Application No.
21/00089/CON

Land North Of Tilehurst Lane and West Of South Lodge Tilehurst Lane Binfield Bracknell Berkshire RG42 5JS

Details pursuant to Conditions 04 (Finished Floor Levels), 11 (Site Organisation), 12 (Working Method Statement), 14 (Biodiversity Enhancements), 23 (Surface Water Drainage Scheme), 24 (Drainage Strategy) of planning permission 17/01174/OUT (Appeal Ref: APP/R0335/W/19/3228697).

OFFICER REPORT

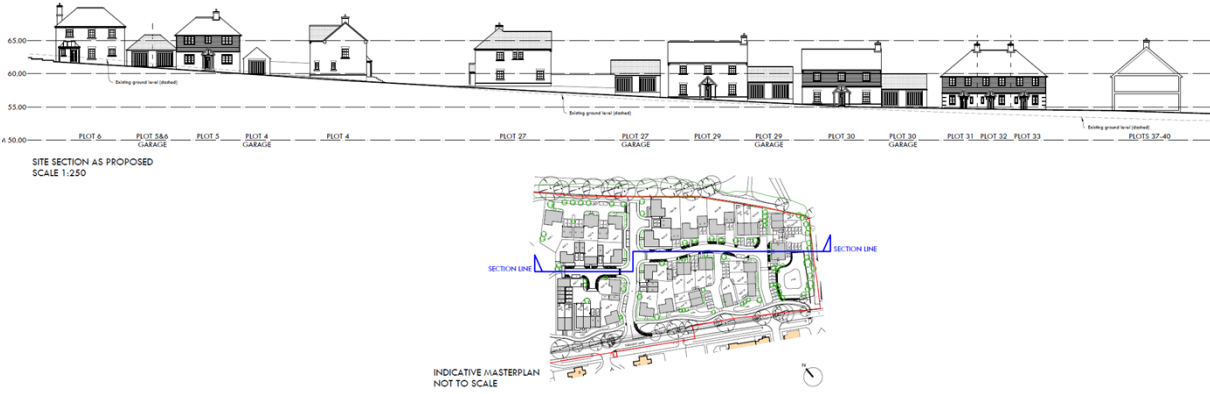
‘However, although Appeal Site A rises to the north-west, the proposed location of the housing would be at a lower level within the least sensitive well screened area’.
- 9.5 The development currently proposed is located within the same area as shown for development within the indicative layout plan before the Inspector.
- 9.6 The below section across the site demonstrates the visual impact of the proposed development.

- 9.7 This shows that ground levels at the north-western corner of the site have been reduced, with the residual land being supported by a retaining wall which varies in height from 0.15m to 1.2m. This will help to reduce the visual prominence of the development as the land rises. Further changes to ground levels would impact on the original concept of the drainage scheme considered by the Inspector which was based on the principle of water flowing down to the eastern end of the site where it will be captured within the attenuation basin.
